QUESTION & ANSWERS

Question 5

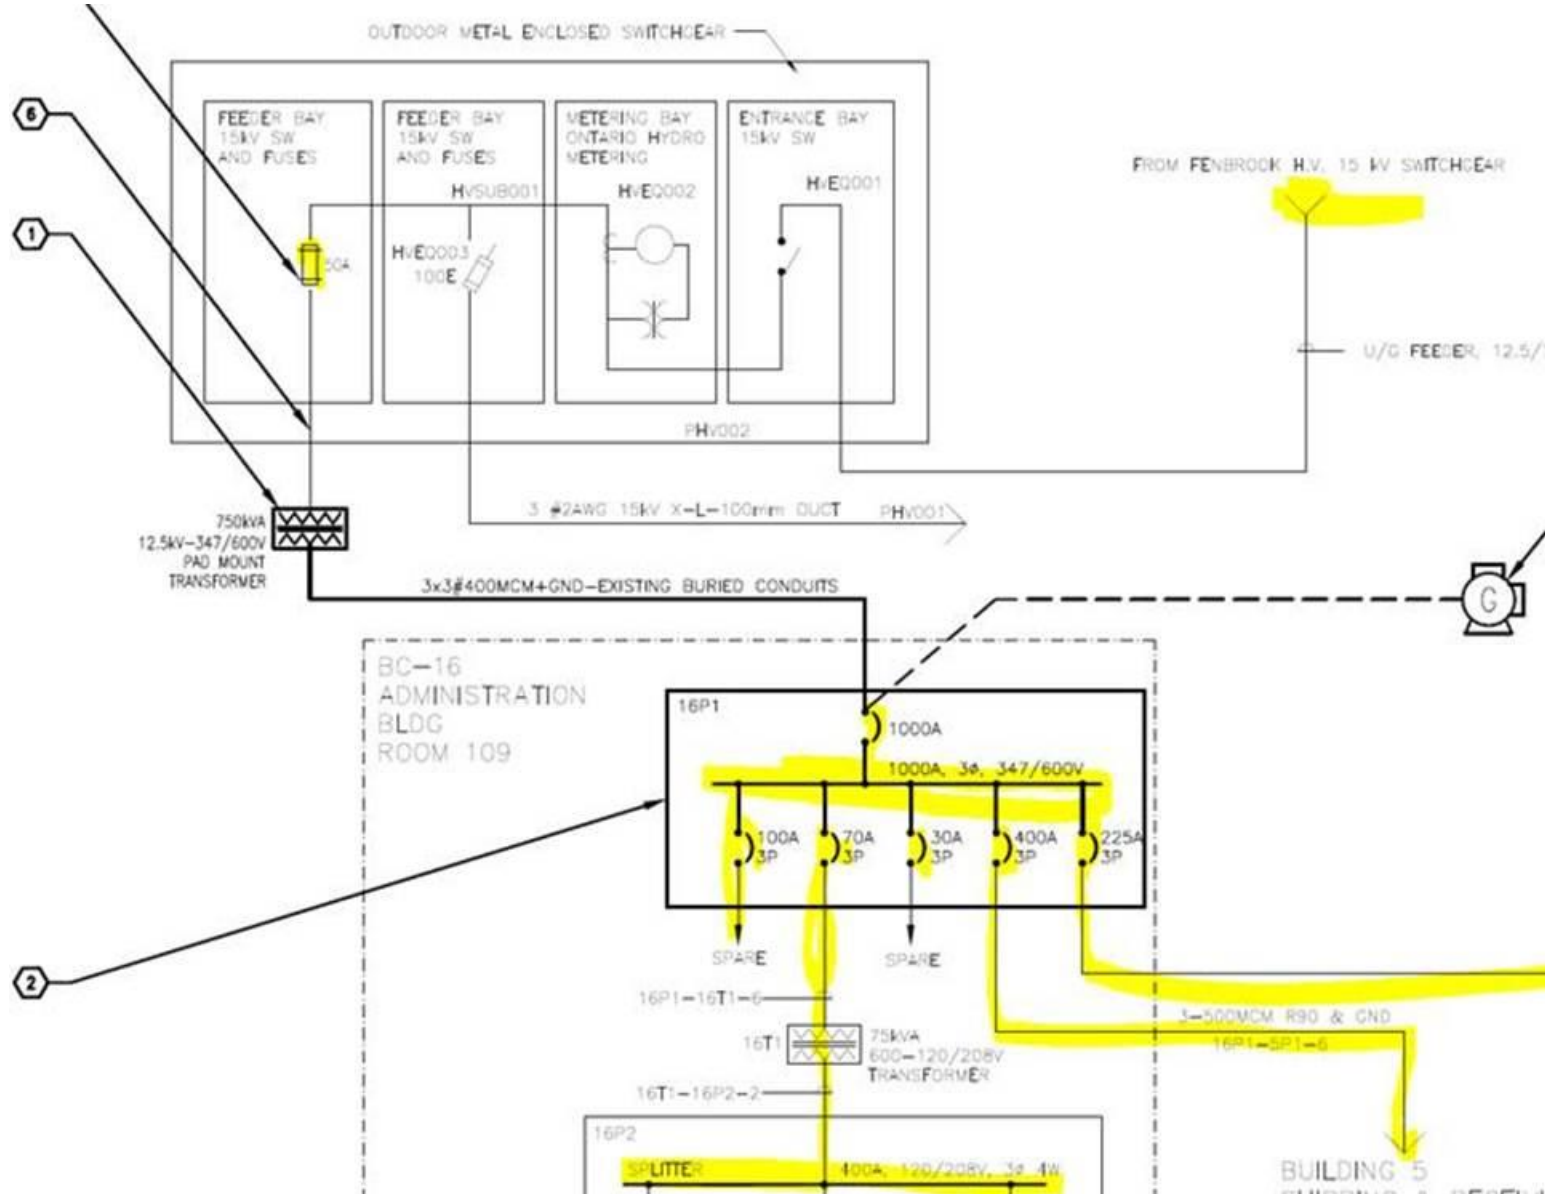
Could I please get a confirmation of what they are looking for. From Section 26 05 01 page 2 we have this:

.2 The scope of the studies shall include:

.1 The Study shall include all relevant distribution and protective devices within the following scope:

- .1 Upstream from the adjacent switchgear protection devices.
- .2 Downstream to the affected branch circuit panels.

This seems to indicate this area should be considered:

We don't have an overall single line diagram, however if arc flash analysis is desired throughout the entire system as defined in sub-section 1.8 then we will need to get the remainder of the system's details (i.e. one lines); specifically the feeder information for the other 12.5kV switch, "HVEQ003" and the G.O. and Building 5 fed from the new 16P1 distribution panel.

Would you be able to confirm the battery limits for the arc flash analysis and confirm that it is in reality limited to the same locations as the coordination and short circuit studies?

The scope of the short circuit, device coordination, and arc flash hazard analysis shall include the equipment affected by this project from the 12.5kV fuse in the switchgear to panel 16P1 inclusively. Existing systems upstream and downstream of this are considered existing to remain.
